**Response to Comments and Errata
for the**

**Old Arcata Road Rehabilitation &
Pedestrian/Bikeway Improvements**

SCH #2021010176

April 2021
Project Ref#: 11159130

17 cars visible

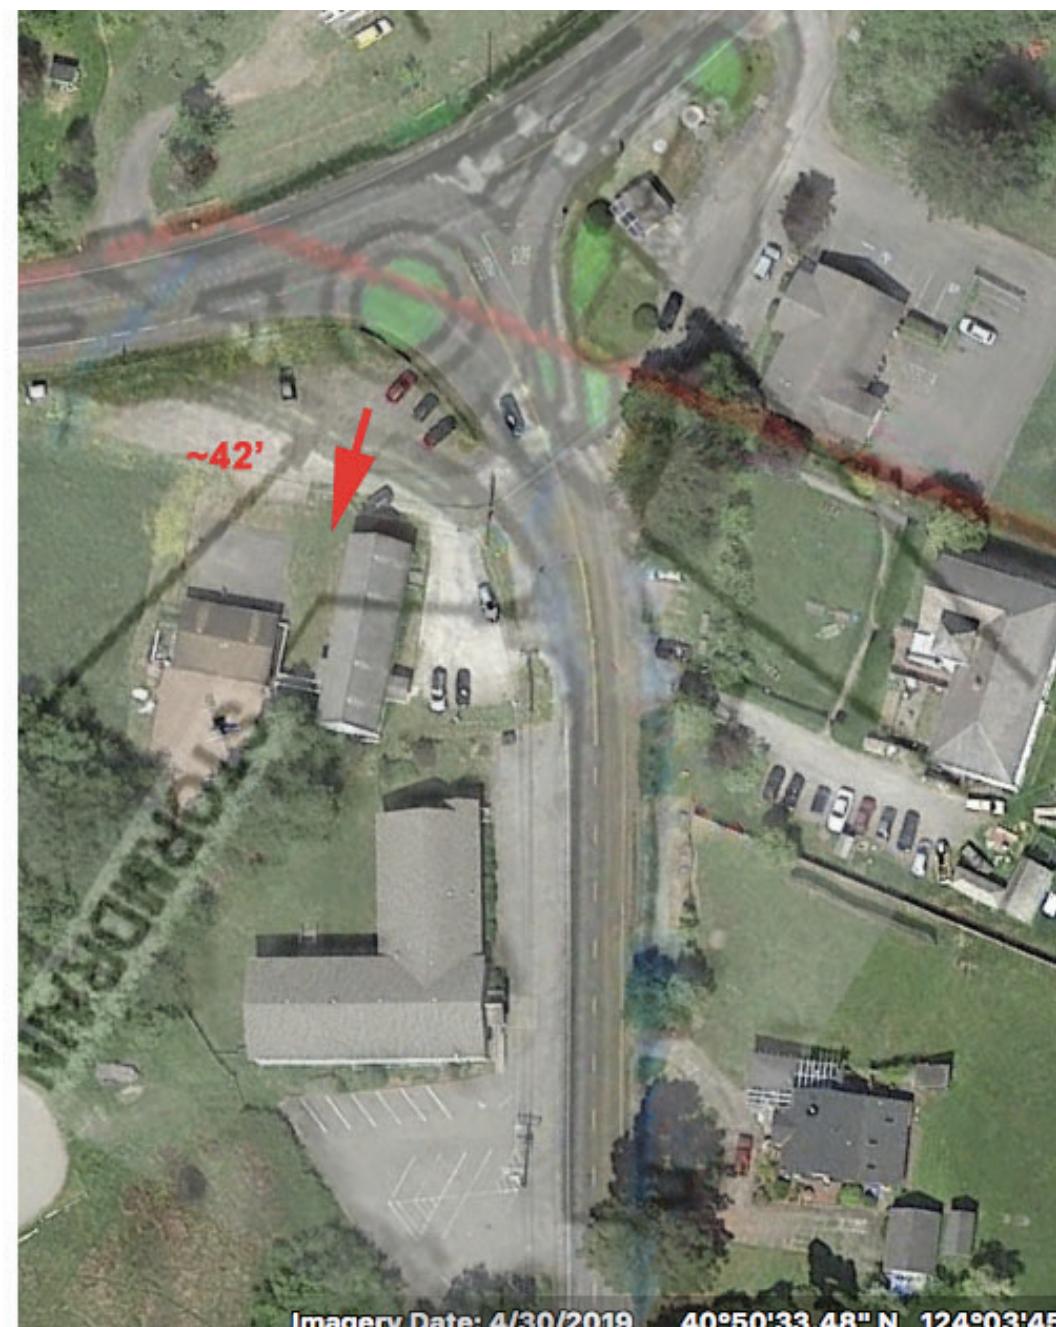
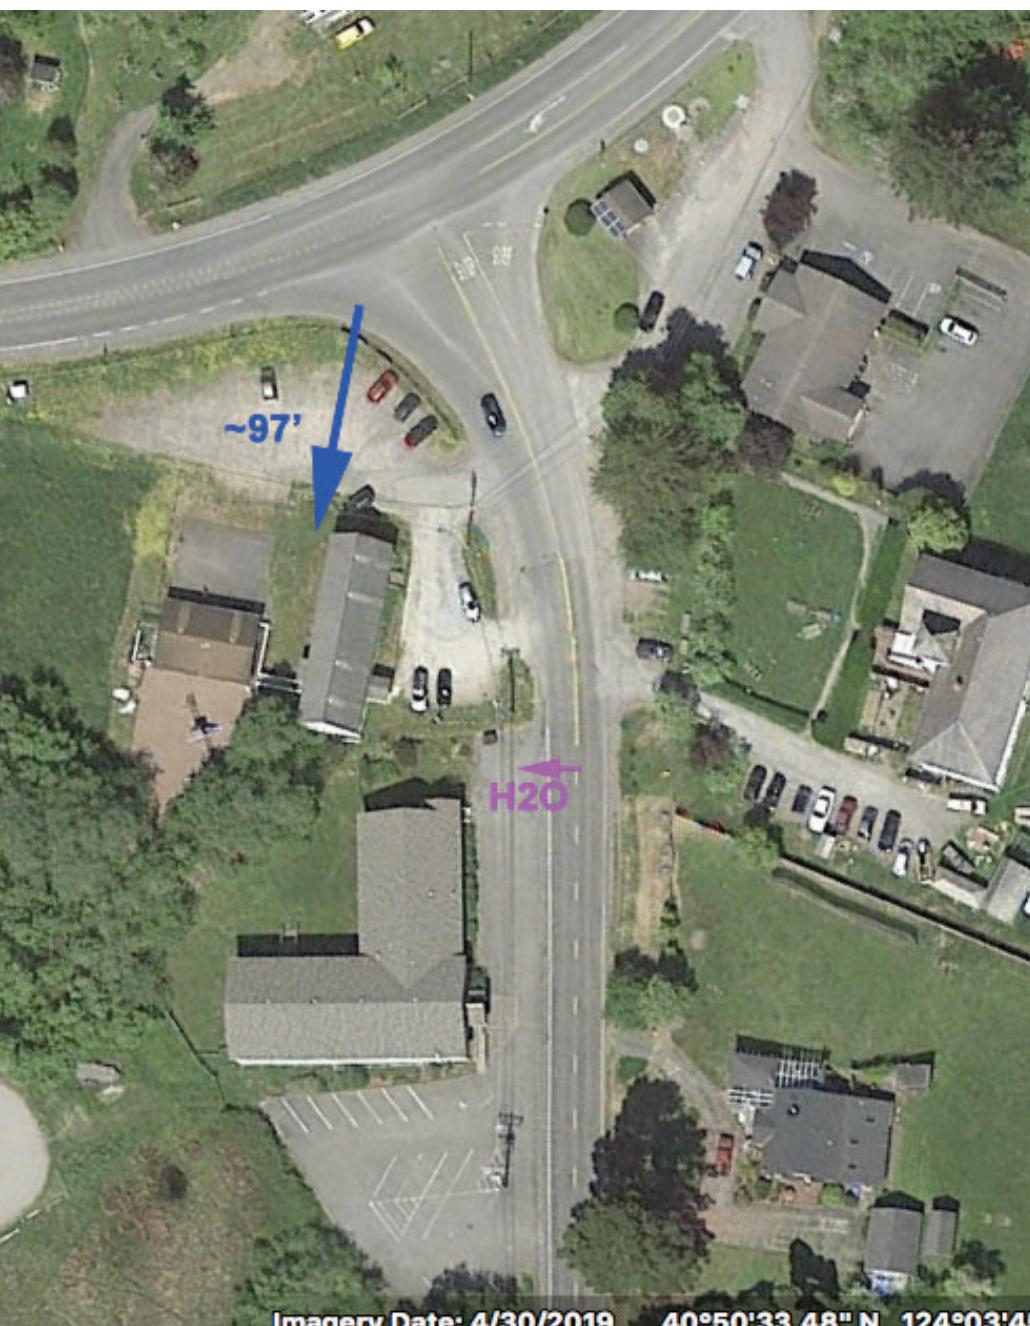
The difficulty is that there is no way to install a roundabout without encroaching into the parking area just west of Mistwood. I was having trouble visualizing exactly what is proposed, given that the MND coyly (and, at this stage, deceptively) states only that "some encroachments onto private property may be necessary and may require acquisitions or easements." "May be" indeed. So I overlaid the relevant portion of Figure 3 from the MND onto a Google Earth Pro image of the intersection – see accompanying figure.

As noted above, I've attached two figures, filenames "BCHParkingAtRisk.jpg" and "BCHParkingRoundaboutFigure.jpg" to illustrate/clarify some of my points.

Response 16-3 – Roundabout

Please see Master Response 2 regarding parking.
